Recap of RWM magnetic sensor upgrade plan for NSTX-U (from 5 Year Plan)

Macrostability Topical Science Group Meeting
February 8th, 2015

Stefan's Comments/Questions re: extended RWM sensors (+ SAS replies)

SPG Idea #1: Mount them under Secondary Passive Plate Lip

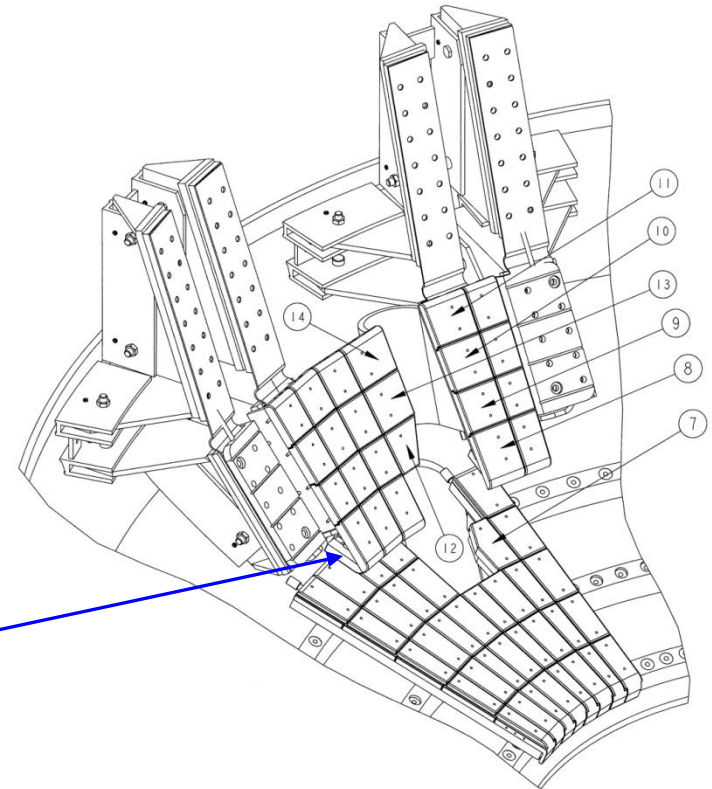
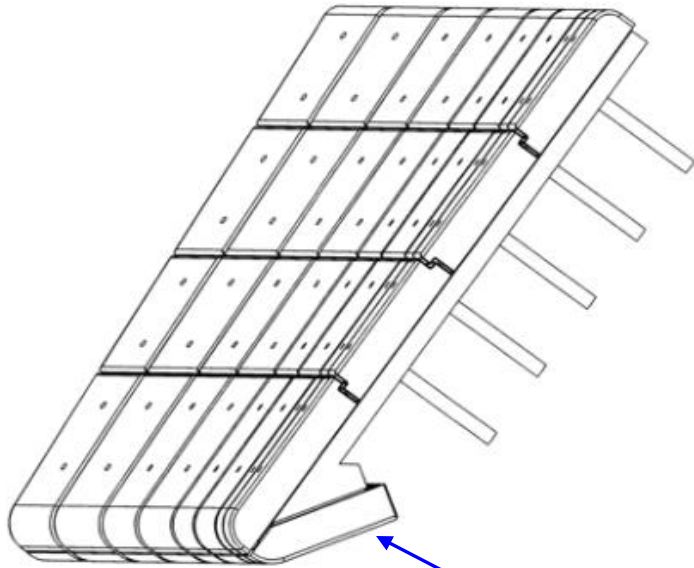
- Replace this tile with sensor box.
- Would be partially shielded by SPP
- Might need to retain part of the front of the tile, but much could likely be eliminated.
- Wire extraction fairly simple.
- Boxes may need to be curved to follow outline of plate.

SPG Idea #2: Mount them under outer divertor bull nose tiles

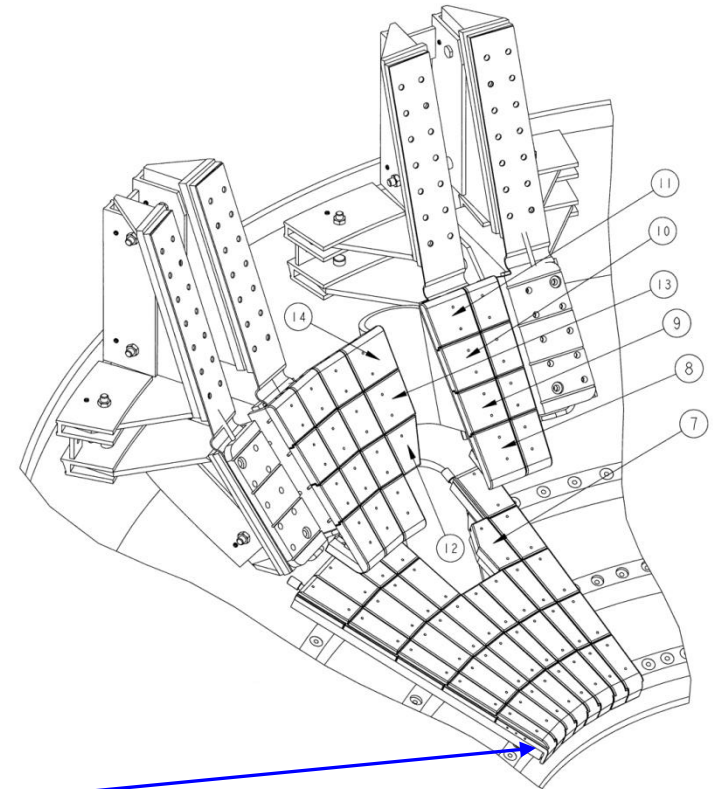
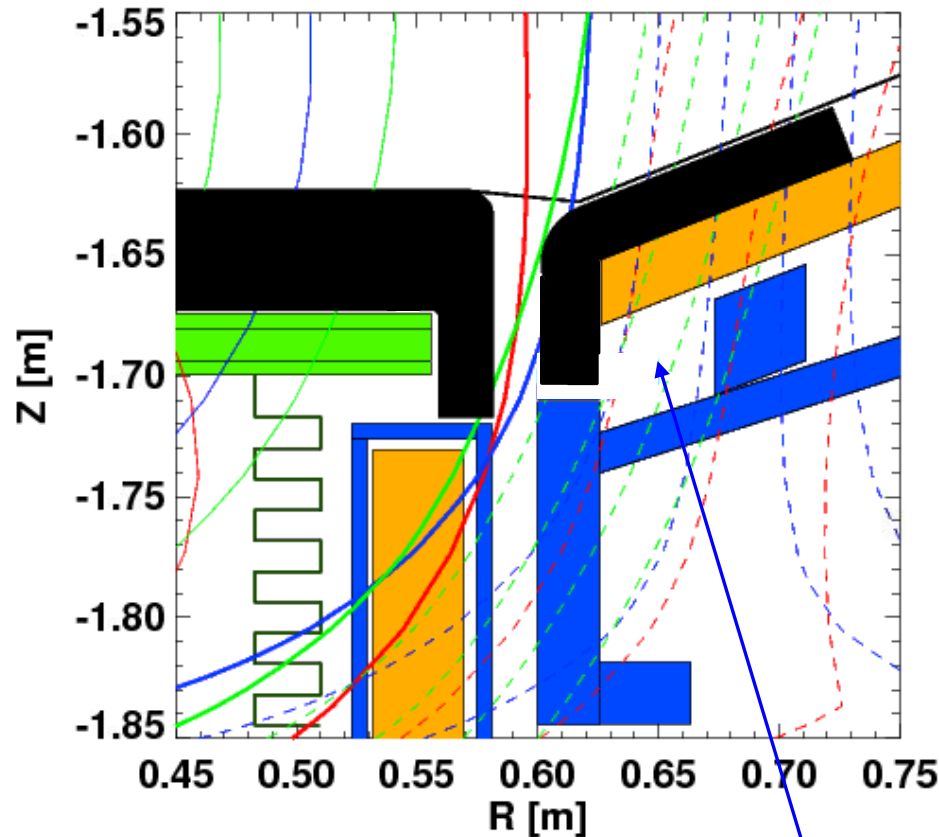
- Place curved sensor box in this volume.
- Is reasonably well shielded from plasma by improved bull-nose tiles.
- Wire extraction likely to be difficult.
- Would be partially electromagnetically shielded by divertor.

SPG Idea #3: Sensors in Tiles

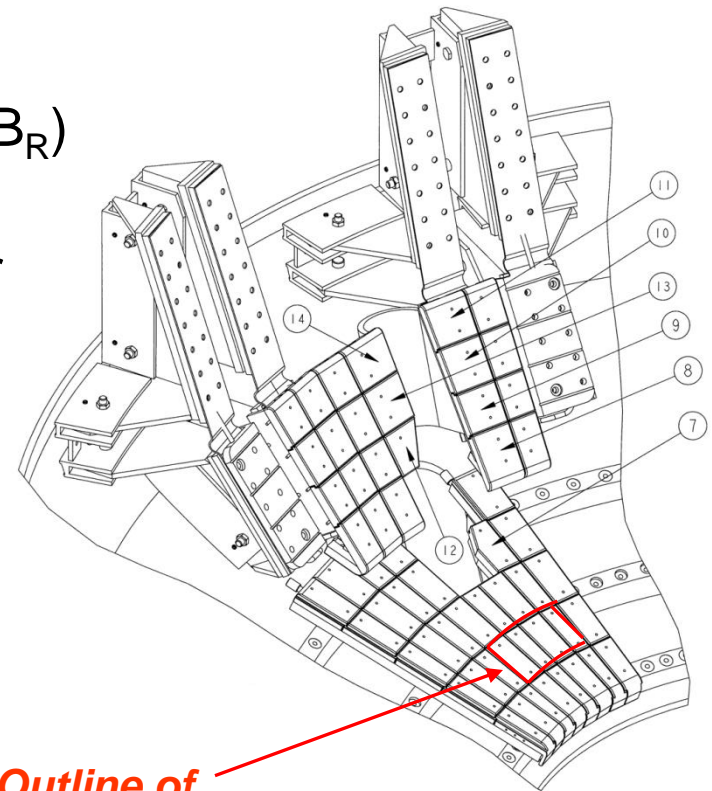
- ❑ Tiles are only about 0.9” thick, and have a T-bar right down the center.
 - ❑ Makes installation of a traditional B_P ($\sim B_R$) sensor difficult.
 - ❑ Could imagine a very thin “Hiro” sensor mounted above the T-bar.
- ❑ Could fabricate a single larger tile, taking the area of 2-4 existing tiles.
 - ❑ Wrap a B_N ($\sim B_Z$) sensor around the tile edges.
 - Sort of like how the B_R sensors are mounted to the PPPs
 - ❑ Would likely trap the t-bars
 - ❑ Are there thermal issues with larger tiles?
 - ❑ Need to check the effective area.

New sensor locations discussed (schematic) (includes possible locations in THIS range (+ one position above midplane))

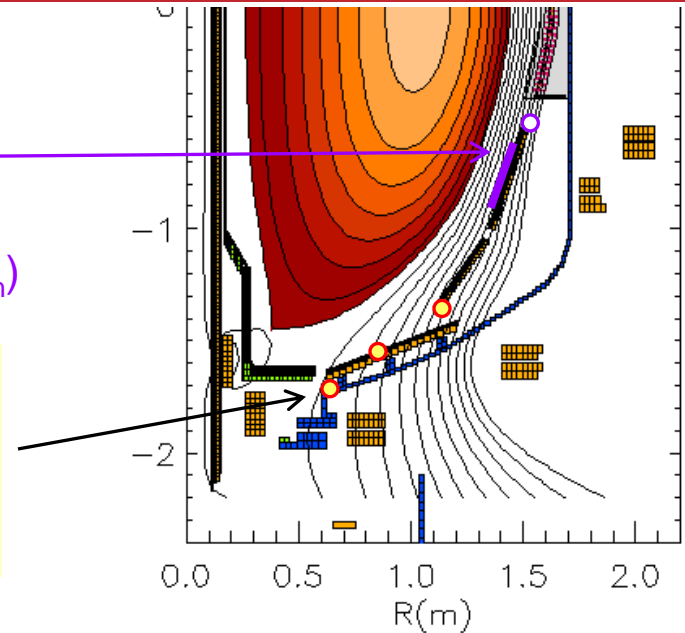
- Present suggestions (based on recent meeting – combination of physics needs, machine hardware constraints, and budget (discussion continues):
 - Consider 12 toroidal positions, 4 arrays (48 sensors) as “baseline”
 - 1st: B_{tan} or B_{norm} at smallest R (best accessible) in outer divertor region
 - 2nd: B_{tan} just below secondary passive plate (in Z position) – (B_{norm} possible here?)
 - 3rd: B_{norm} sensors in the lower divertor tiles (R position TBD)
 - 4th: B_{norm} or B_{tan} sensors at smallest R (best accessible), **opposite Z** in outer divertor
 - Are other positions possible to improve higher n (higher m) detection?

- ❑ Is it necessary that these be up/down symmetric?
 - ❑ Maybe focus on LSN discharges for the first installation?
 - SAS comment: Up/down asymmetric ok – also has advantage of higher m resolution (helps address comment by Jong-Kyu regarding higher n's)

- ❑ Is likely premature to consider the details:
 - ❑ Is lower divertor going to be modified for pumps or lithium systems?
 - Suggested locations need changes if a cryopump placed in lower divertor.

- But, cryopump would also allow for opportunities for sensor integration
 - Reply: Sensors to be installed at same time / must be compatible w/cryo.
 - ❑ How many years of operating with these sensors is required to make them worth the effort?

- SAS: Even one year would provide key data, and results might argue to keep them in (e.g. for improved operation of RWM state-space controller)
- ❑ Who will do this work?
